# CITY OF ALBUQUERQUE

**RE: Lot 23 Block 2 Unit SAD 227  
5605 Popo Dr. NW  
Grading and Drainage Plan  
Engineers Stamp Date 4/3/2020 (E10D076)  
Pad Certification Date 6/28/2020**

## DRAINAGE AND TRANSPORTATION INFORMATION SHEET (REV 6/2018)

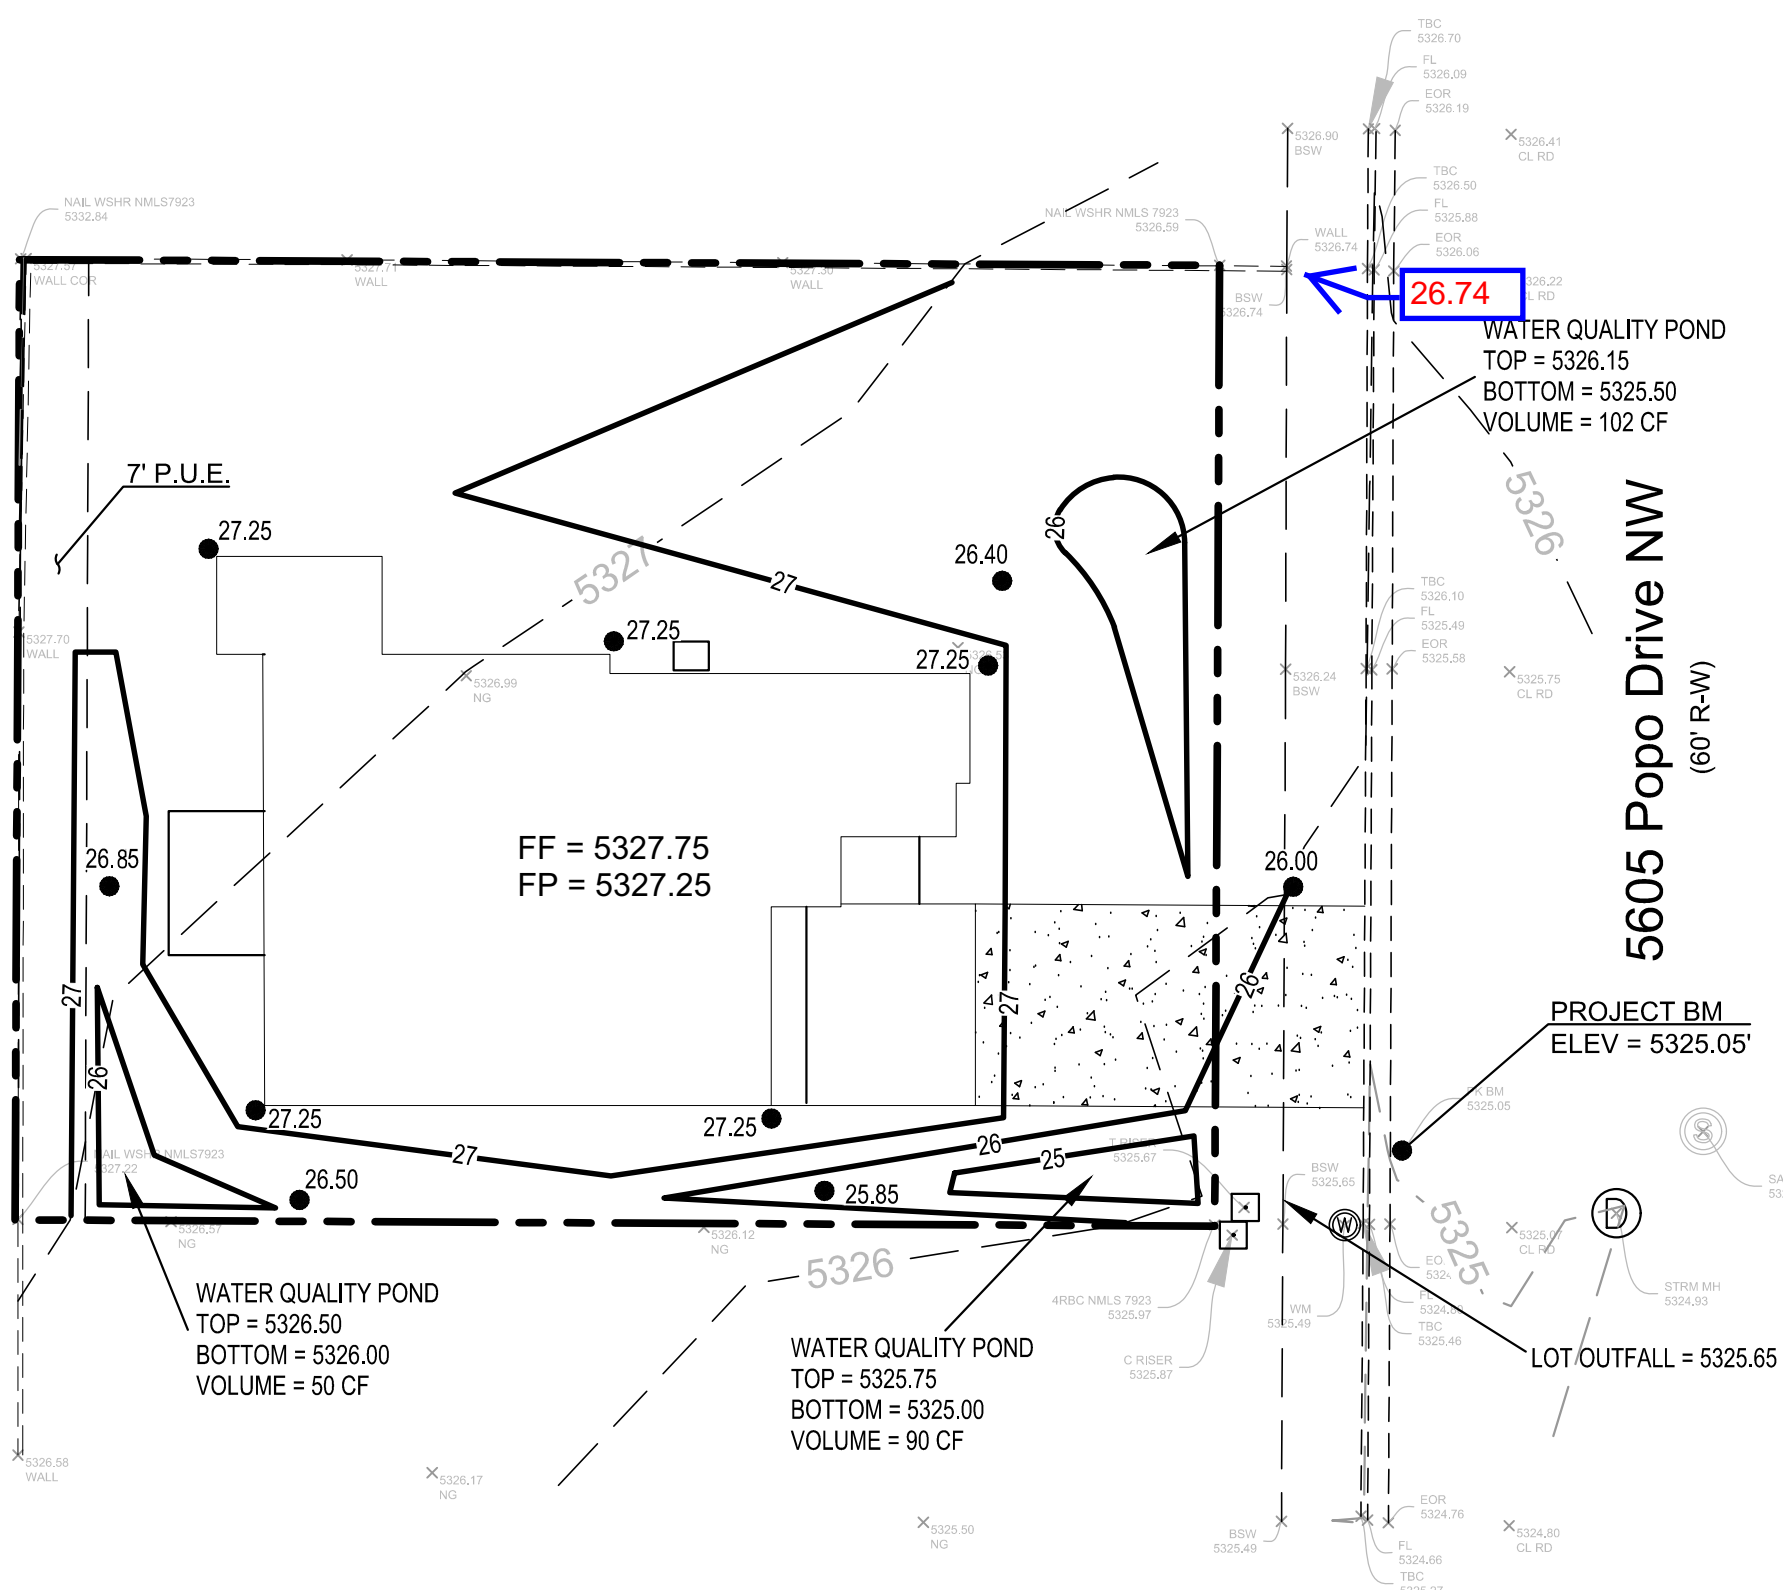
Based upon the information provided in your submittal received 4/8/2020, this plan is approved for Building Permit.

Reiterate to the Owner/Contractor that a separate permit for a garden/retaining wall must be obtained, with the approved G&D plan.

Prior to Certificate of Occupancy release, Engineer Certification per the DPM checklist of this plan will be required.
